BUILDING CODE OF AUSTRALIA COMPLIANCE ASSESSMENT REPORT FOR DA SUBMISSION

PROPOSED LOADING DOCK ALTERATIONS

22 CENTRAL AVENUE, MANLY

REPORT NO. ► 7375.1_R02_FINAL

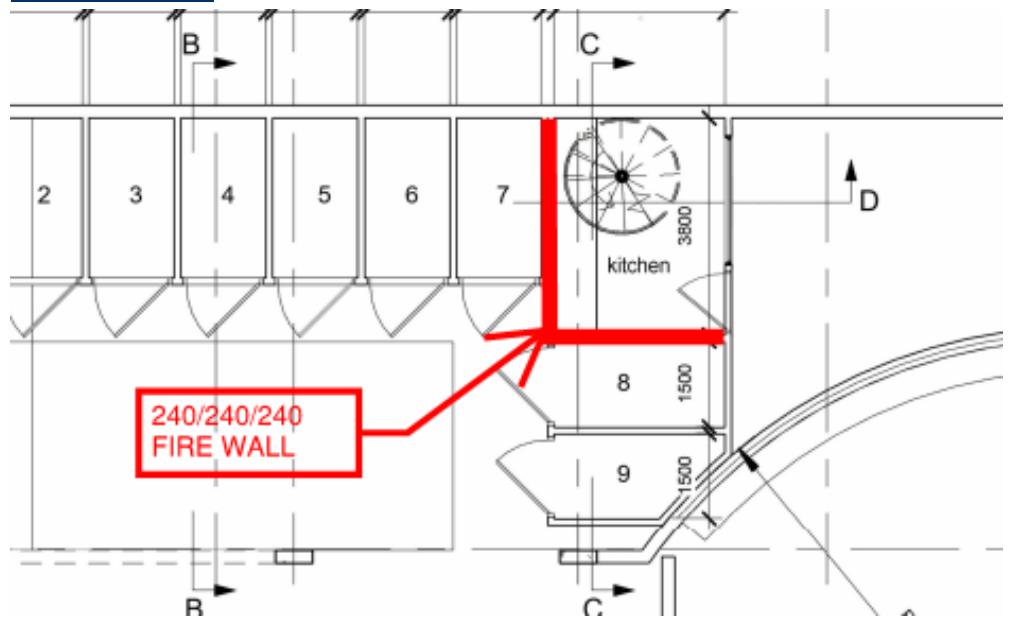
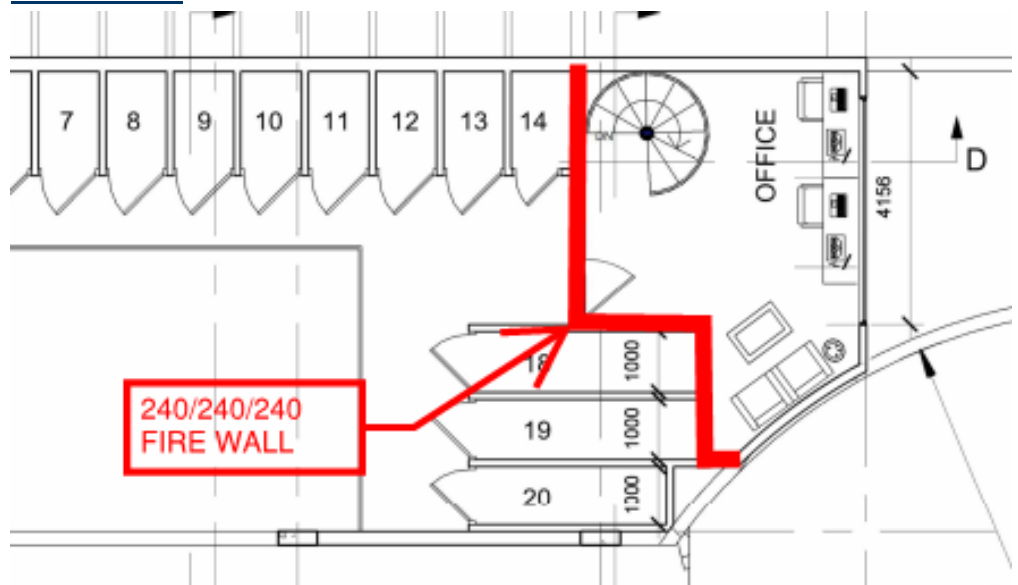
- The Class 5 office is required to be separated from the Class 7b storage area / loading dock by a fire wall achieving an FRL of not less than 240/240/240 where loadbearing, or -/240/240 where non-loadbearing. AED recommend that a fire engineer is engaged to rationalise this FRL.

Note: Fire stopping systems achieving an FRL of -/240/240 for service penetrations through walls are not currently available. Hence, a performance solution should be obtained where services are proposed to penetrate the fire wall. Furthermore, rationalising the FRL will improve constructability.

Basement Level

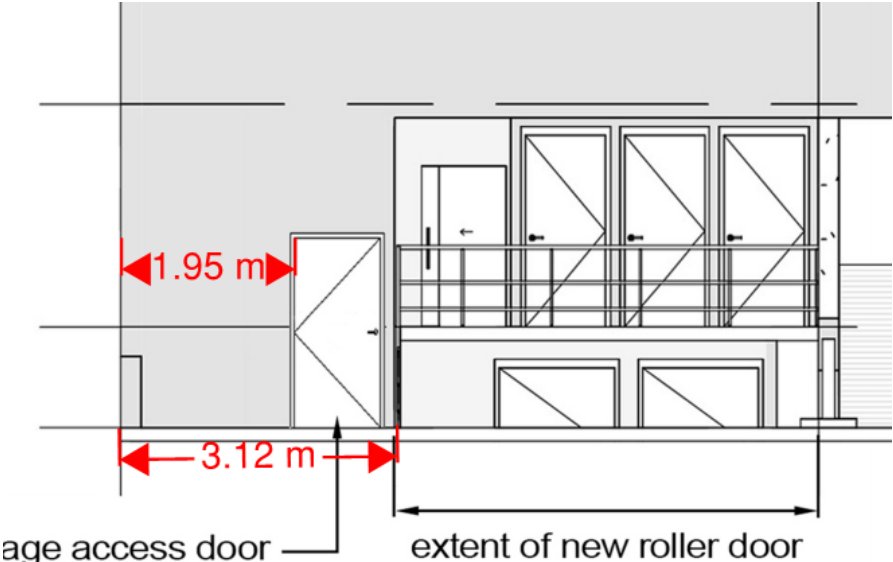
Note 2: There are more than 2 classifications on both the basement level and ground level, as such the exemption under Clause A6G1 cannot be applied. Class 5, 6, 7a, and 7b.

Note 3: The requirements of this clause only apply to the internal walls separating classifications, being the Class 5 office part and Class 7b storage / loading dock.
